#### PLAN COMMISSION STAFF REPORT

Agenda Item: PC Docket No. 20-008

Summary: BCORE Corridor Chicago LLC represented by Kimley-Horn requesting approval of

a development plan to expand the driveway, alter a parking lot, and install landscaping and screening at the GE Appliance Distribution Center at 475

C3.0

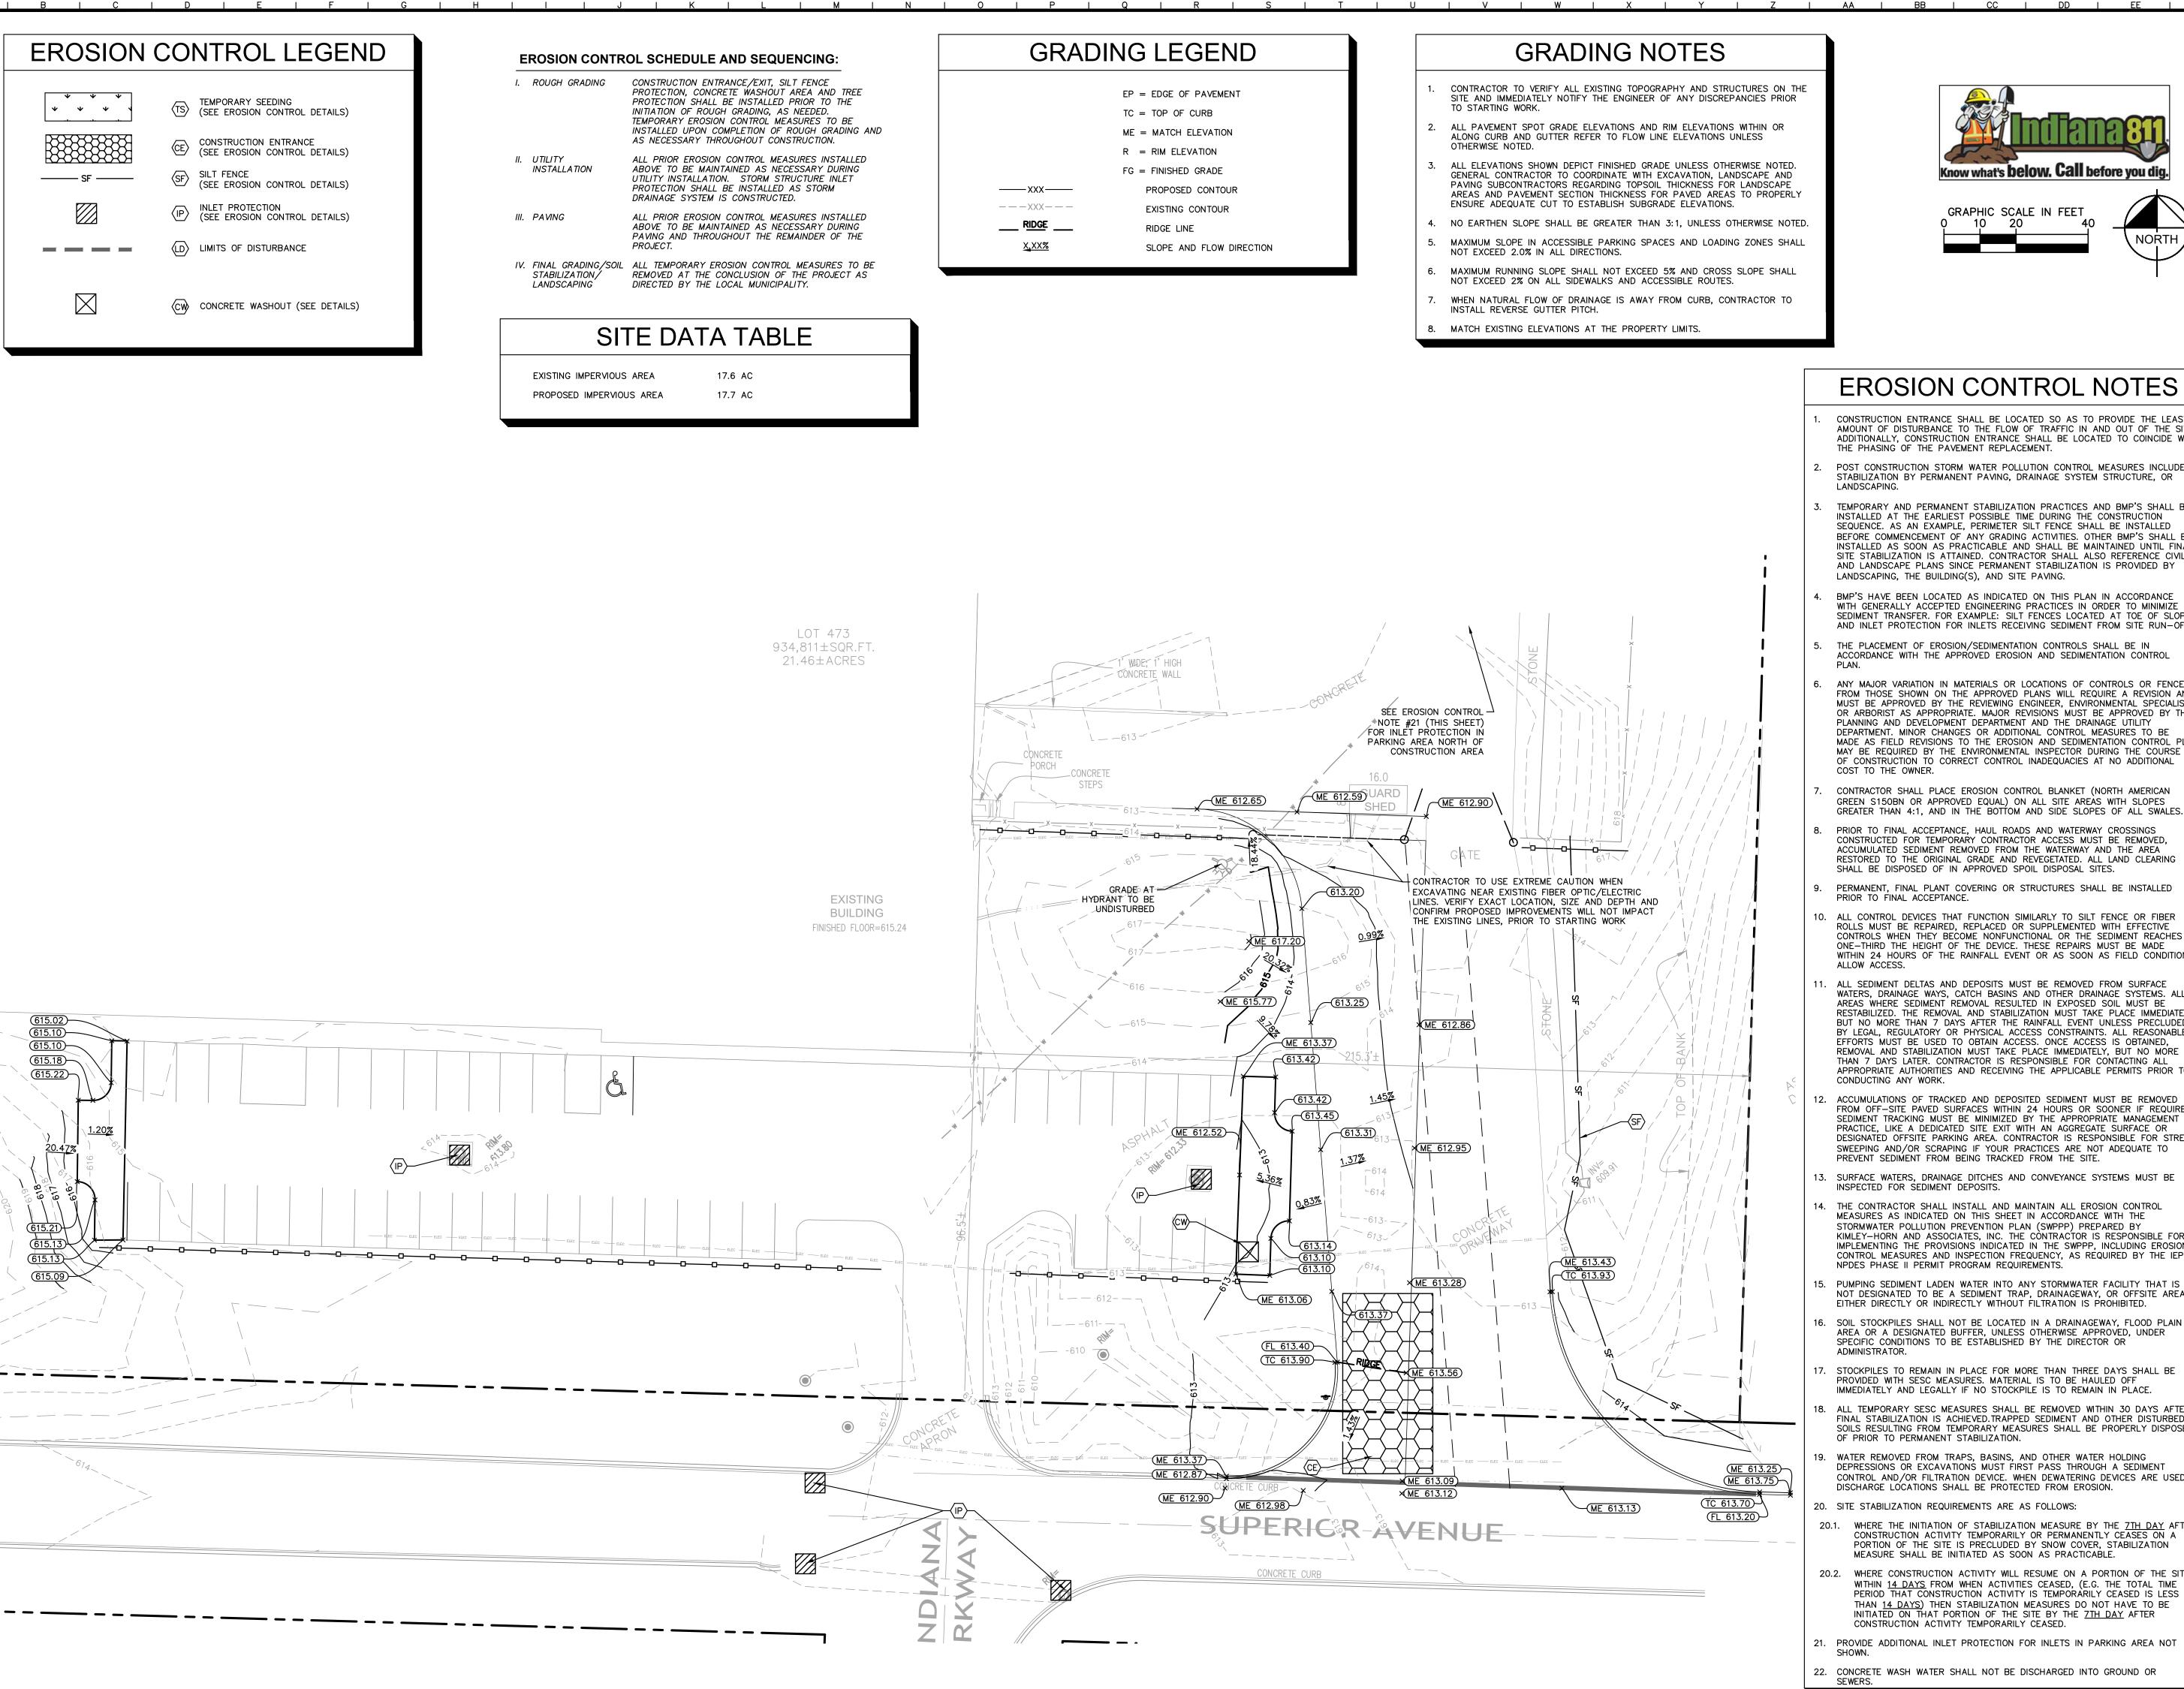
The proposed width of the driveway far exceeds the standard of the Munster zoning code which limit driveway width to 24', but the applicant is seeking a variance from that standard. Under normal circumstances, staff would not recommend such a large curb cut, driveway apron, or driveway, but because this is an existing business seeking to address a known issue, staff is supporting the driveway expansion.

The project will expand the driveway from 41 feet to 60 feet wide, with a 75-foot-wide apron at the front property line. The widened driveway will serve as additional truck queuing area to prevent the stacking of semi-trucks on Superior Avenue. To make room for the widened driveway, two parking spaces will be eliminated on the east side of the employee parking lot that is located south of the building. The employee parking lot will be expanded to the west to replace the parking spaces.

L1.0

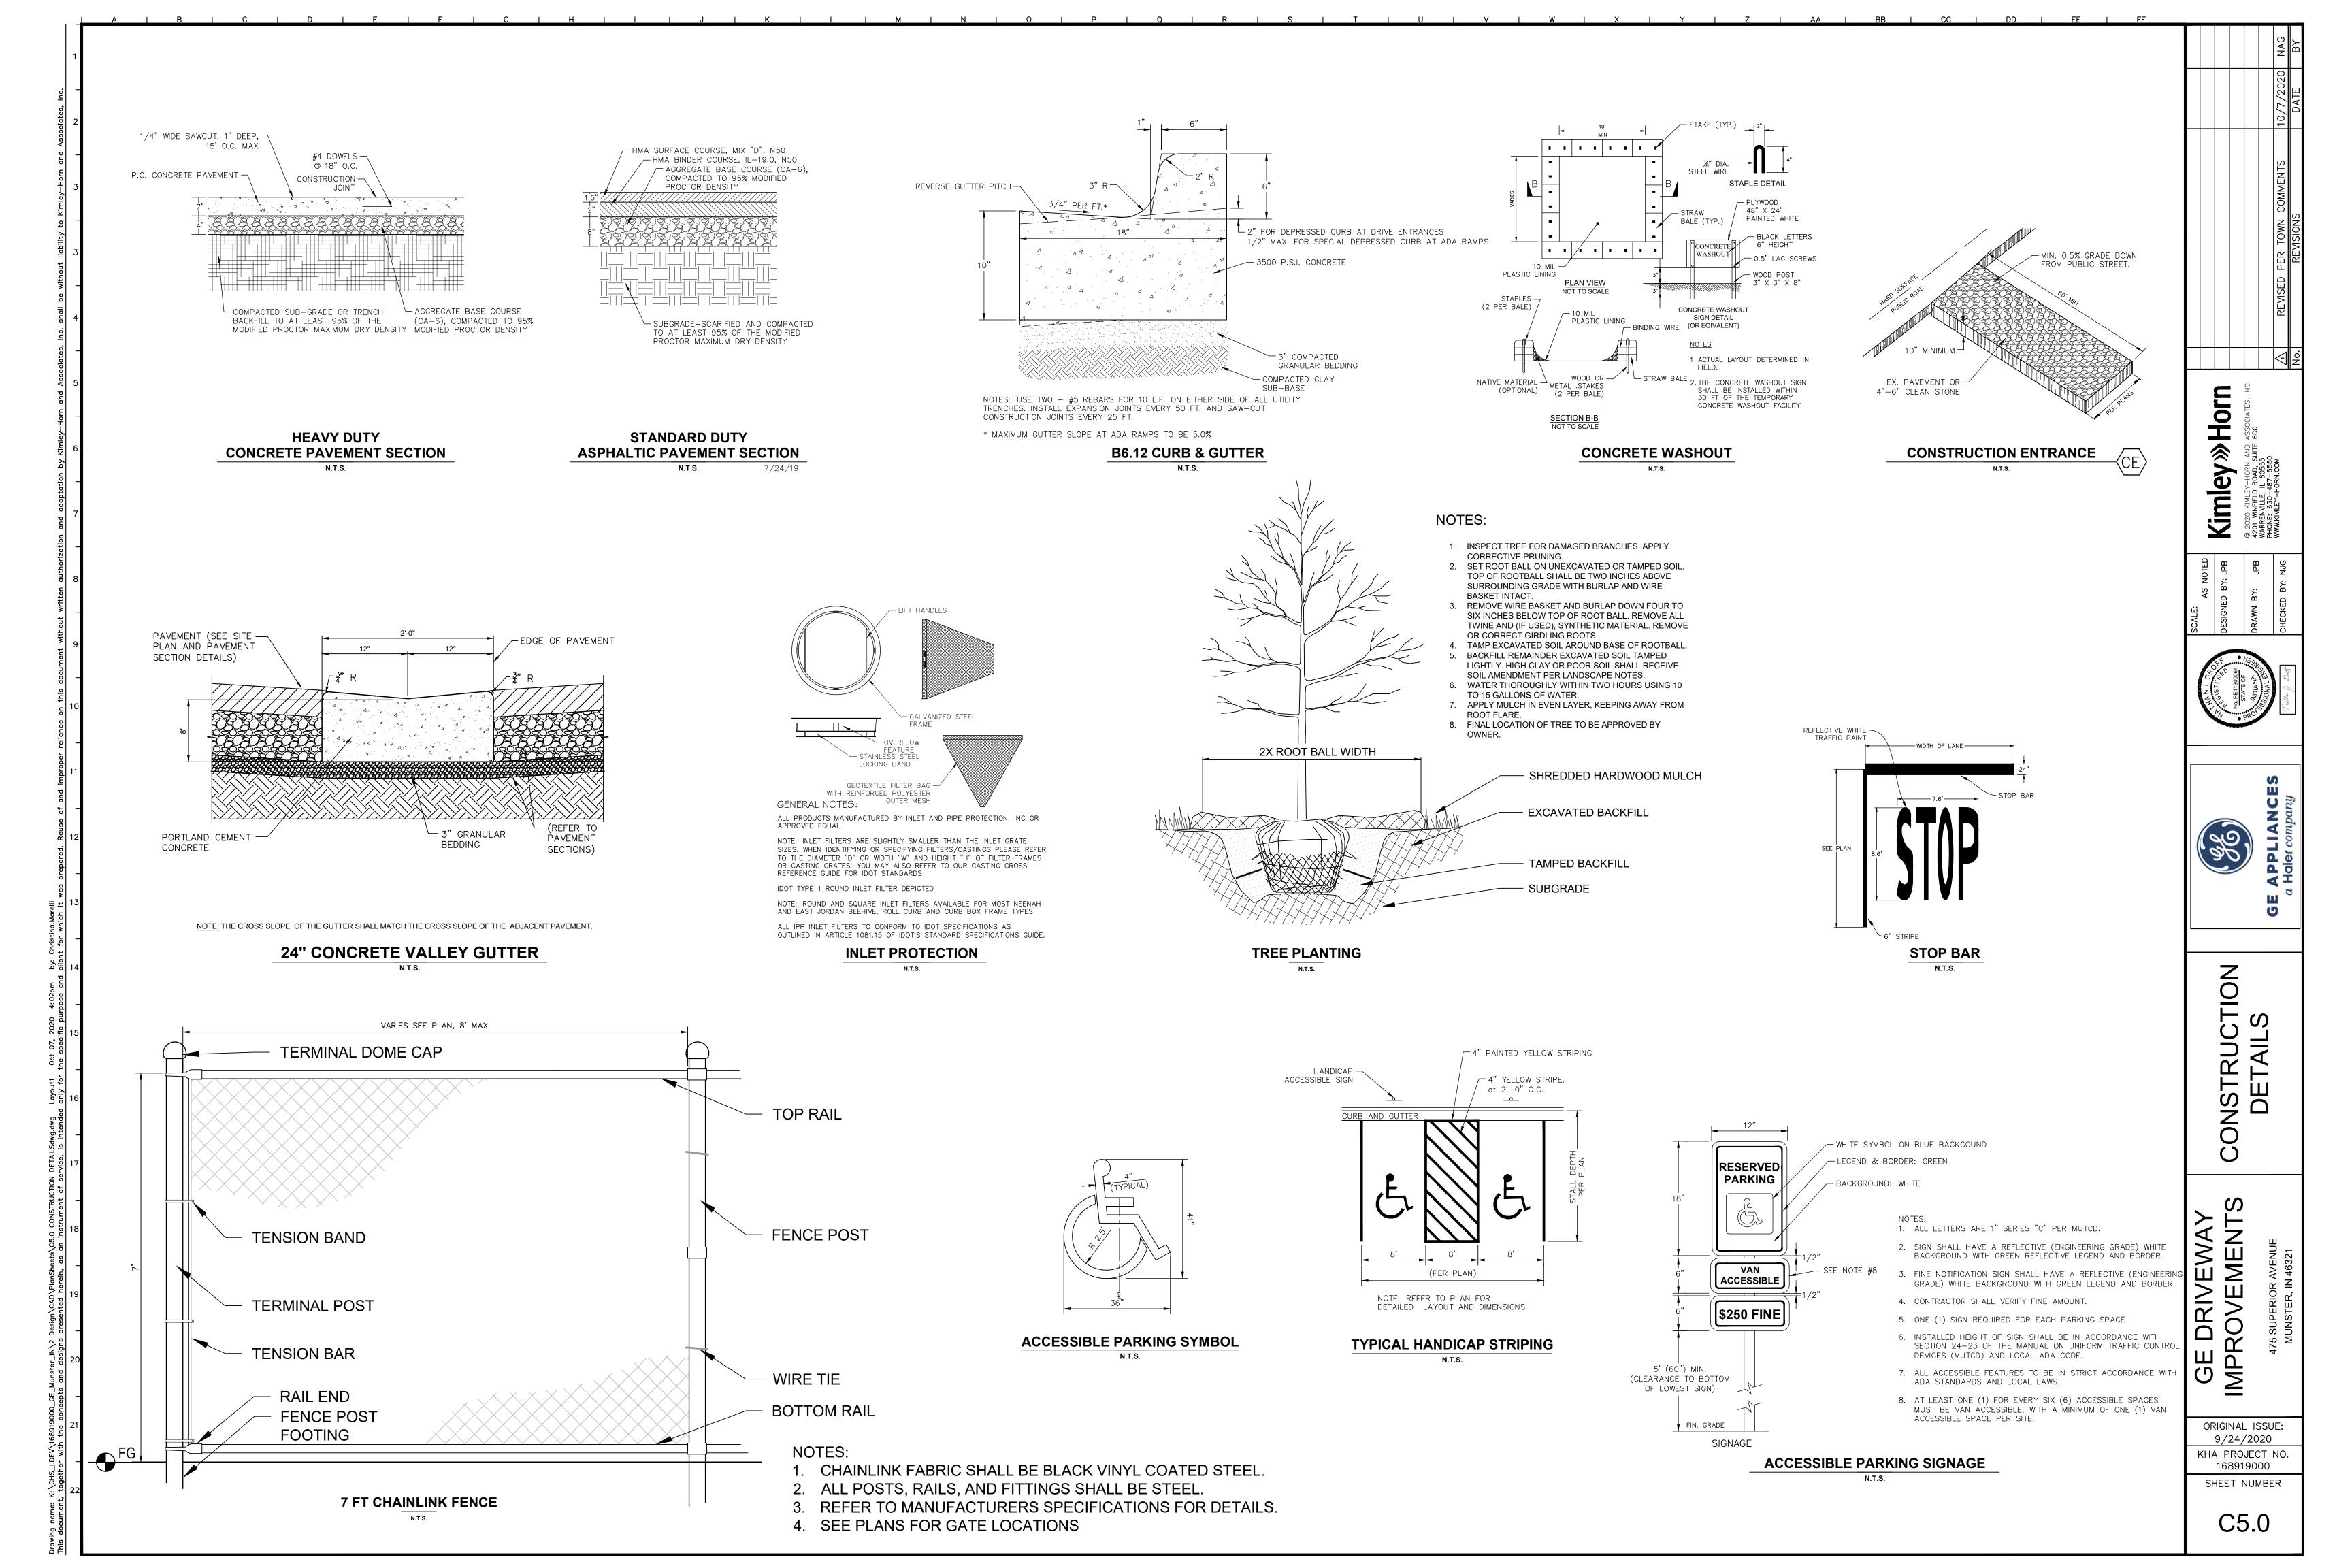
Table 26-6.405.A-7 of the Munster zoning ordinance states Loading Areas are to be screened from frontage by a 6 foot wall, hedge, or fence. The applicant is providing a 6' wooden board-on-board fence to screen the loading area from the frontage.

Section 26-6.405.P.1 of the Munster zoning ordinance states that minimal parking area expansions require screening of the parking area. For parking in the first lot layer, the required screening is a 7-foot perimeter planting strip that includes a hedge screen, a wall or fence screen, and shade trees planted at 30 feet intervals. The applicant has provided a landscaping plan meeting those requirements.

MUNSTER, IN LANDSCAPE CODE										
ZONING ORDINANCE	REQUIREMENT	PROVIDED								
DIVISION 4 - SECTION 26-6.405 BUILDING AND LOT STANDARDS - A: DISTRICT BUILDINGS AND LOTS - SCREENS										
PARKING AREAS SHALL BE SCREENED FROM FRONTAGE AND CIVIC SPACE BY A STREETSCREEN. THE FENCE SCREEN OR STREETSCREEN SHALL BE CONSTRUCTED FROM WOOD.	A 6 FT. OPAQUE FENCE IS REQUIRED ALONG THE PERIMETER OF THE LOADING DOCK	A 6' OPAQUE FENCE IS PROVDED ALONG THE PERIMETER OF THE LOADING DOCK								
DIVISION 4 - SECTION 26-6.405 BUILDING AND LOT STANDARDS - O.2: VEHICULAR AND BICYCLE PARKING, LOADING SPACE AND TRASH RECEPTACLES - SIGNIFICANT TREES										
TREES BETWEEN 10 IN. AND 16 IN. DBH THAT ARE REMOVED FOR DEVELOPMENT SHALL BE REPLACED AT A 1 TO 1 RATIO.	3 TREES REMOVED ALONG THE SOUTH EDGE OF THE SITE	3 REPLACEMENT TREES ARE LOCATED ON THE SOUTH SIDE OF THE SITE								
COMMERCIAL LANDSCAPE REQUIREMENTS - SECTION 3 - PARKING AREA SCREEN

A MINIMUM 7 FT. WIDE PERIMETER PLANTING STRIP SHALL BE PLANTED ADJACENT TO THE PUBLIC RIGHT-OF-WAY. THIS PLANTING STRIP SHALL CONTAIN A CONTINUOUS HEDGE SCREEN, AN ORNAMENTAL FENCE SCREEN AND ONE SHADE TREE PLANTED FOR EVERY 30 FT. OF LINEAR FRONTAGE.	LINEAR FRONTAGE OF PARKING: 243.3 FT. 243.3 FT. / 30 FT. = 8.1 8 SHADE TREES REQUIRED	A 7' PLANTING STRIP, A 3' ORNAMENTAL FENCE AND 8 SHADE TREES ARE PROVIDED ADJACENT TO THE PUBLIC RIGHT-OF-WAY
